Regular Meeting
Design Review Board
September 1, 2016
7:00 p.m.

AGENDA
TIBURON DESIGN REVIEW BOARD

1. 85 EAST VIEW AVENUE

To: Members of the Design Review Board
From: Planning Manager Watrous
Subject: 85 East View Avenue; File Nos. DR2016091, VAR2016026, VAR2016027, VAR2016028, VAR2016029, VAR2016030 & FAE2016009 ; Site Plan and Architecture Review for Construction of a New Single-Family Dwelling, with Variances for Reduced Front and Side Setbacks, Excess Lot Coverage and Excess Building Height, and a Floor Area Exception
Reviewed By: _____

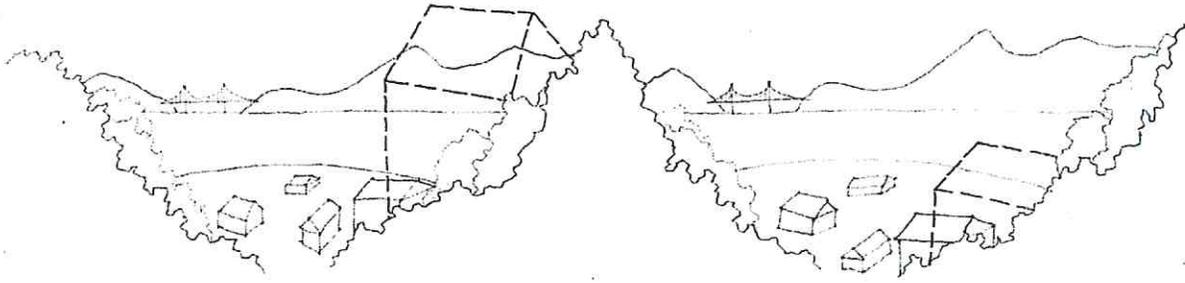
Goal 3, Principle 7 (B) of the Hillside Design Guidelines states that the “horizon line is [the] most sensitive part of [the] view, then foreground, then middleground.” The proposed home would be in the foreground view and extend past the horizon line from the home at 83 East View Avenue. The house would be situated in the middleground of the view of the home at 87 East View Avenue.

2. BLOCKAGE OF CENTER OF VIEW MORE DAMAGING THAN BLOCKAGE OF SIDE OF VIEW.

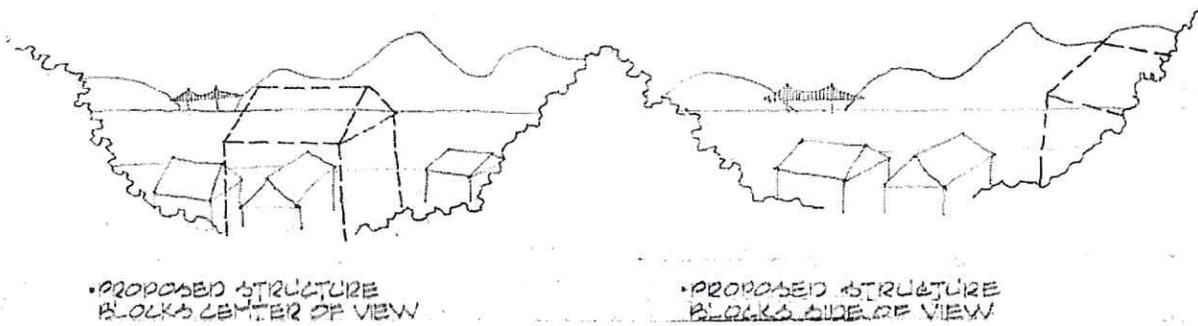
Goal 3, Principle 7 (C) of the Hillside Design Guidelines states that “blockage of center of [the] view [are] more damaging than blockage of [the] side of [the] view.” The proposed house would intrude into the side of the view from the home at 83 East View Avenue, but the center of the view from the kitchen and dining room. The living room of the home at 87 East View Avenue has windows on two sides, with the proposed house sitting in the center of one of the windows.

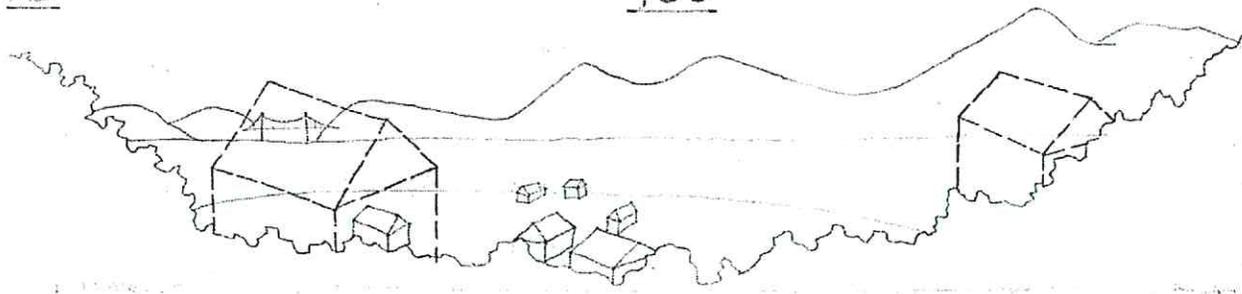
Goal 3, Principle 7 (C) of the Hillside Design Guidelines states that “blockage of important objects in the view (Golden Gate Bridge, Belvedere Lagoon, Sausalito, Angel Island) is more difficult to accept than blockage of other, less well-known landmarks.” The proposed house would block views of Mt. Tamalpais and Belvedere Lagoon from the kitchen and dining room of the home at 83 East View Avenue and would block views of San Francisco Bay and Angel Island from the living room of the home at 87 East View Avenue.

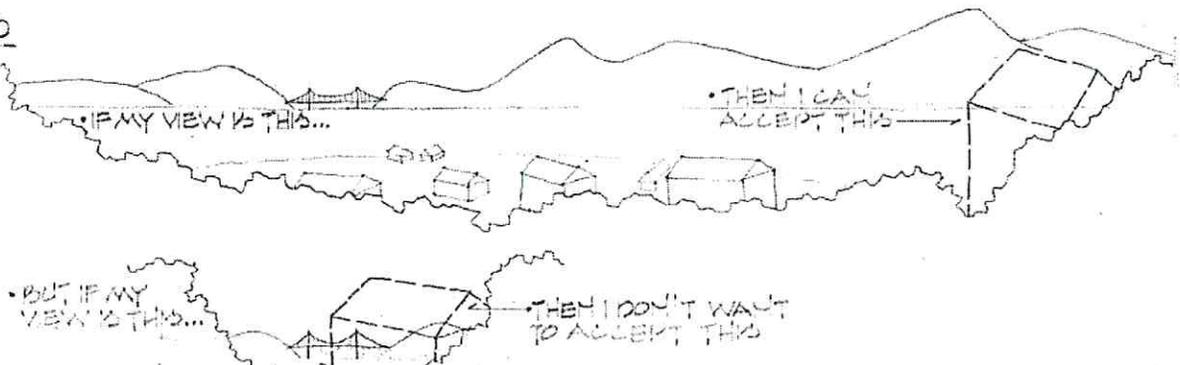
Goal 3, Principle 7 (E) of the Hillside Design Guidelines states that “a wide panoramic view can accept more view blockage than the smaller slot view.” The home at 83 East View Avenue has a relatively panoramic view to the north and west, while the home at 87 East View Avenue has bifurcated views to the east and west.

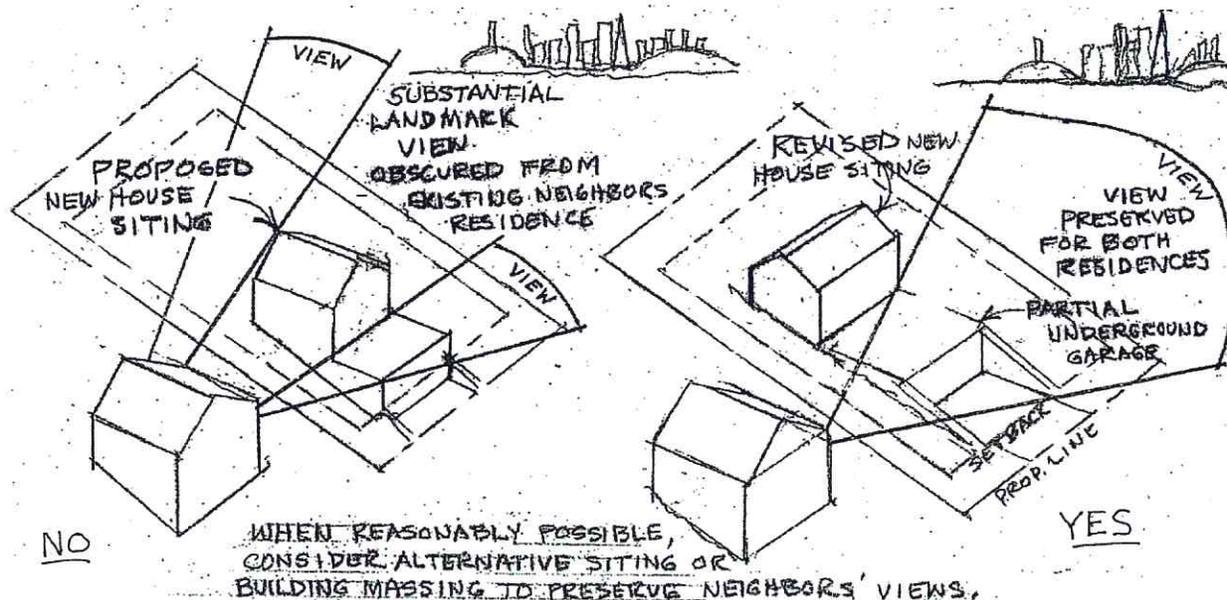
Goal 3, Principle 8 of the Hillside Design Guidelines states that “a view across a vacant lot is often considered to be a ‘borrowed’ view, which is likely to be compromised by the eventual development of the vacant lot. A borrowed view is one which is temporary in nature and which may be reasonably expected to change upon development of the lot. Consideration may be given to preserving portions of a borrowed view if this is the only substantial view for a neighboring home.” The views from the dining room and kitchen of the home at 83 East View Avenue are directly across the subject site and could be considered to be borrowed views. The view from the living room at 87 East View Avenue is currently limited by the home at 83 East View Avenue beyond the subject property and only a portion of the proposed house would extend beyond the other neighboring home and into views toward Angel Island.
